13, BARTONS ROW, EGTON.
APPLICATION No. NYM/2018/0095/FL

Drawing:
PROPOSED
ELEVATIONS.

Drawing:
PROPOSED SITE &
GROUND FLOOR PLANS.

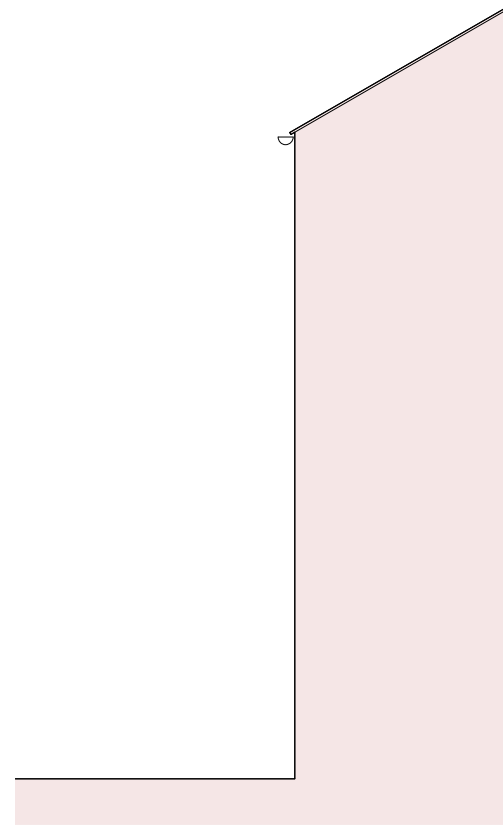
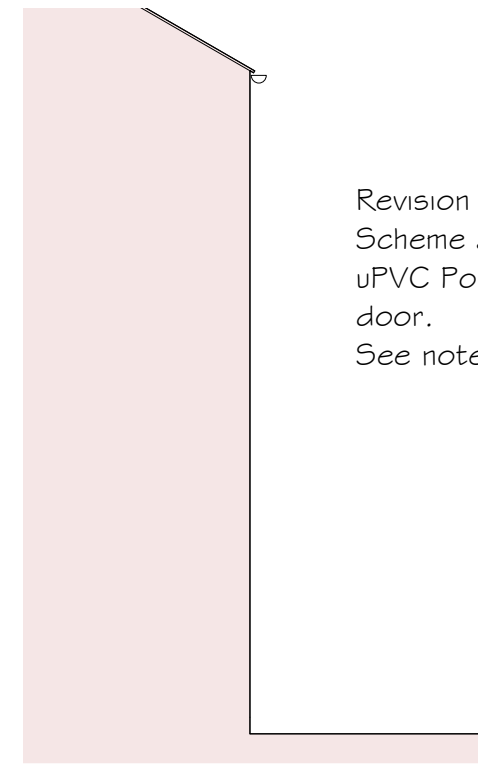
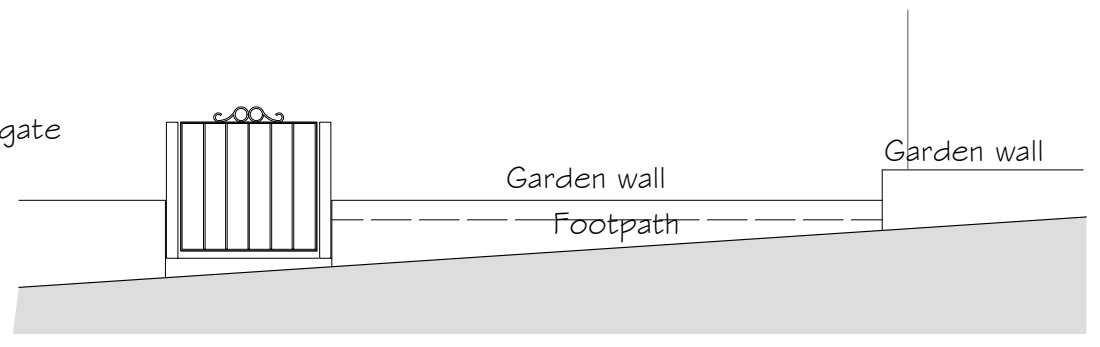
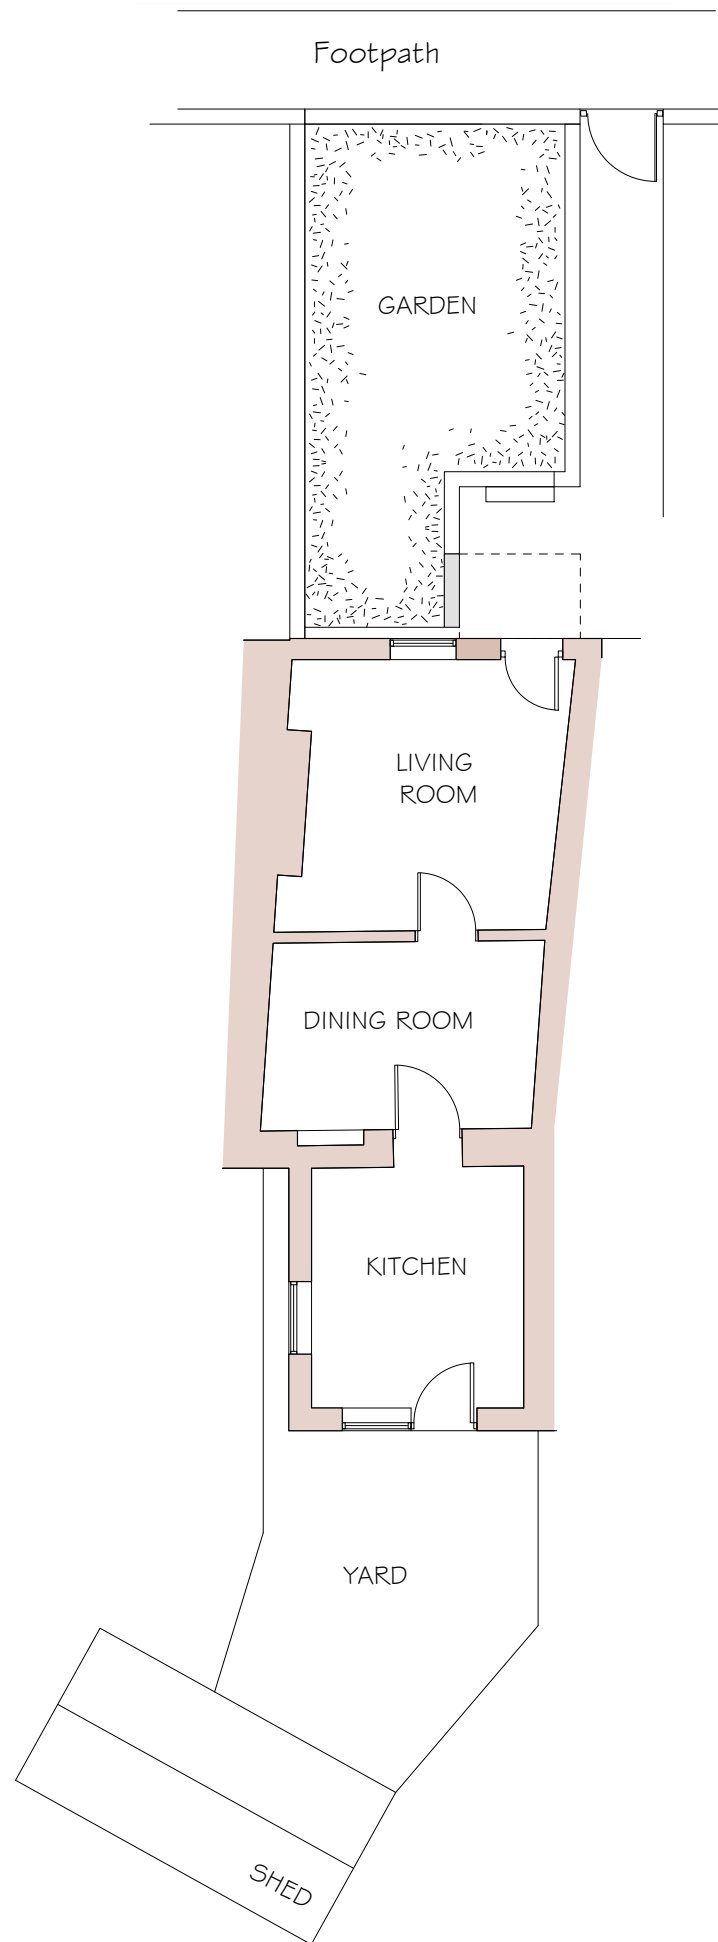
Make good harling finish where
Porch removed to match existing.

New composite door with
timber board patten finish
as photo. To fit existing opening.

New outside light fitting
coach lamp as Client requirements.

Revision A. 27/04/2018
Scheme amended to remove
uPVC Porch & replace front
door.
See notes.

The scheme now shows that the uPVC Porch will be completely removed and will not be replaced. Existing remaining and exposed work is to be repaired and/or re-instated to match the existing such as the paving, garden wall and wall finish where the Porch is removed.

The existing front door, presently a half glazed aluminium model, is proposed to be replaced with a timber pattern composite door. The reason for this, is that the property is heated by a ground source heat pump and would need to rely on the better 'U' value that this door would provide as opposed to a timber panel door. That aside, it would be more appropriate door since the windows in the terrace are predominantly uPVC, the neighbouring property has a uPVC door and at no.11 a mahogany multi-panel door features. It is considered that the composite door balances the heating system requirements of the building with an appropriate appearance in the Conservation Area.

The applicant would like to fit a coach lamp between the front door and window opening.

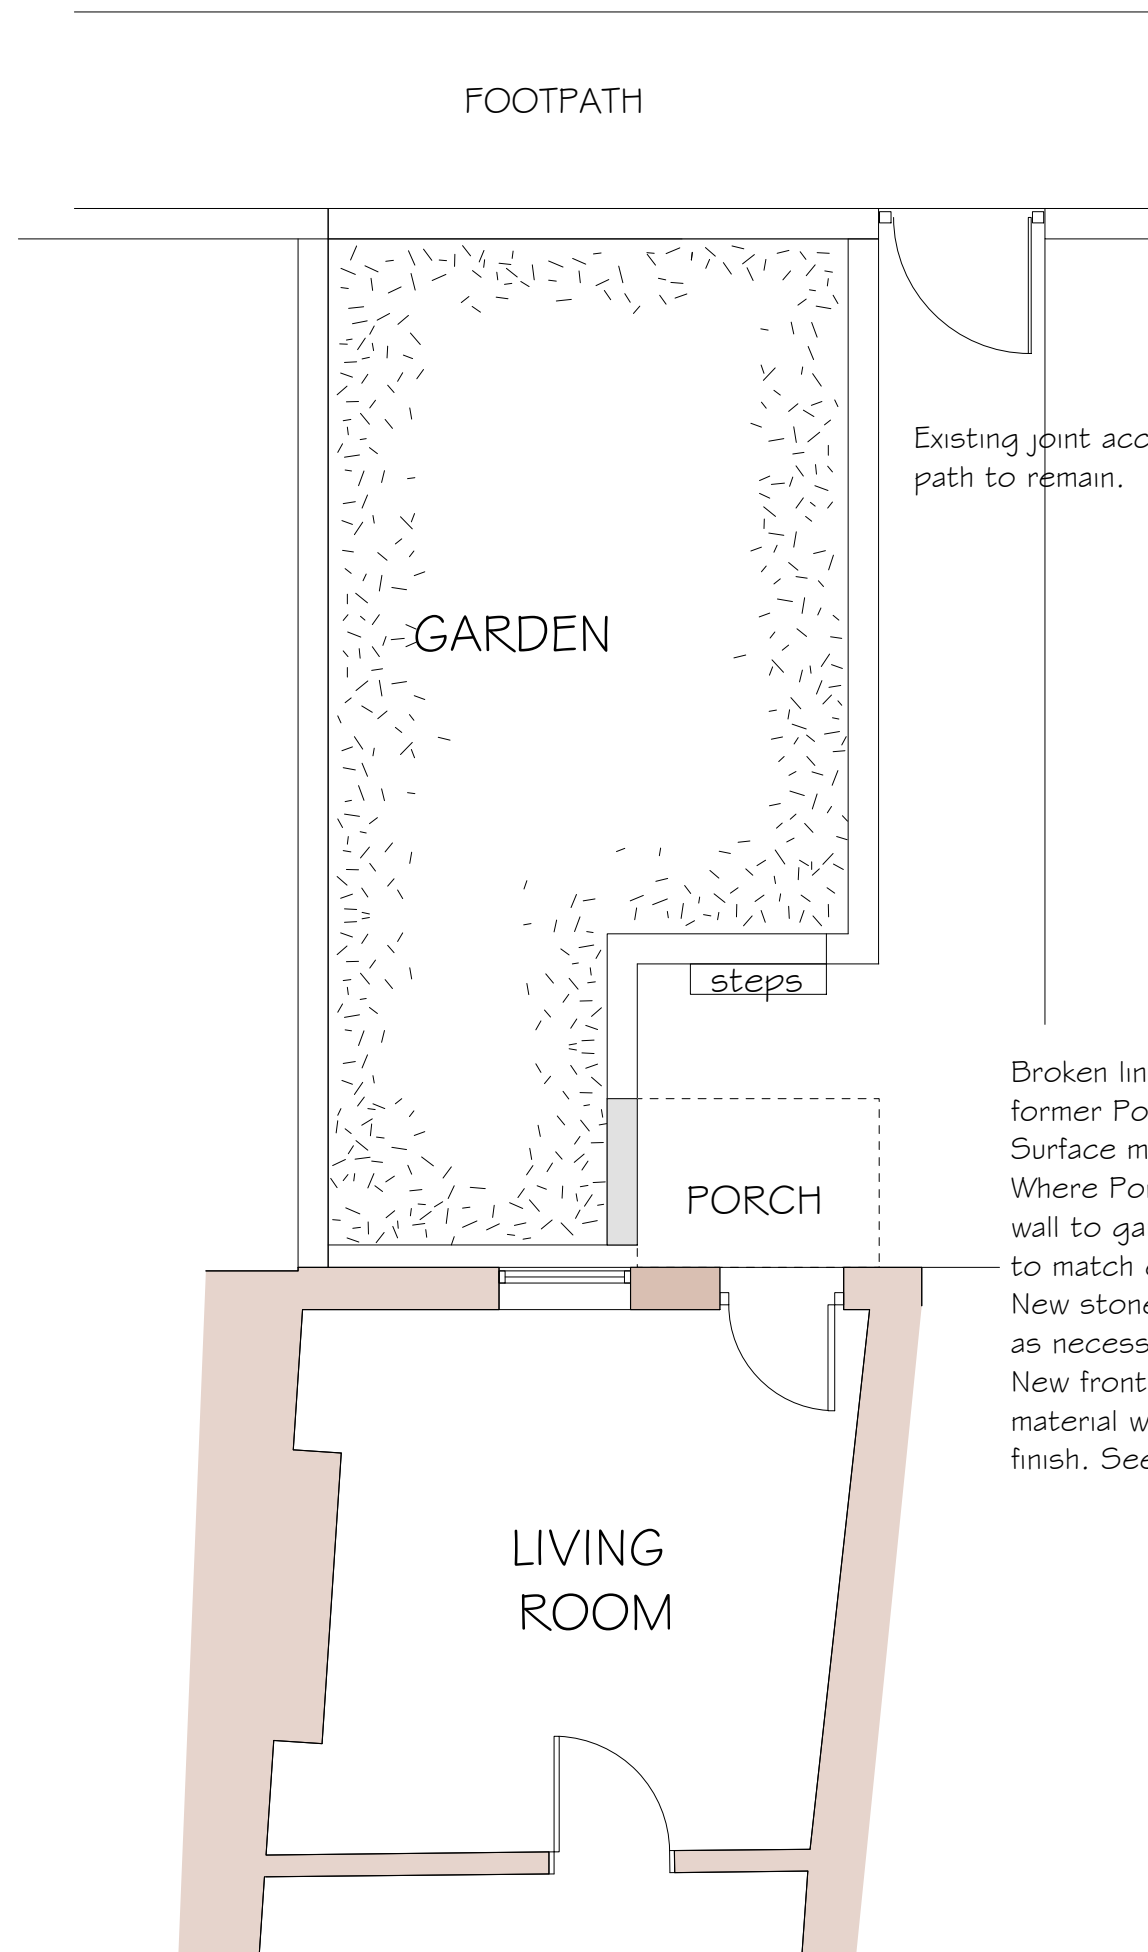
Broken line shows site of former Porch, to be removed. Surface made up to match existing. Where Porch removed build up wall to garden area in stonework to match existing. New stone step to front door as necessary. New front door in composite material with timber board pattern finish. See elevations.

Revision A. 27/04/2018
Scheme amended to remove uPVC Porch & replace front door.
See notes.
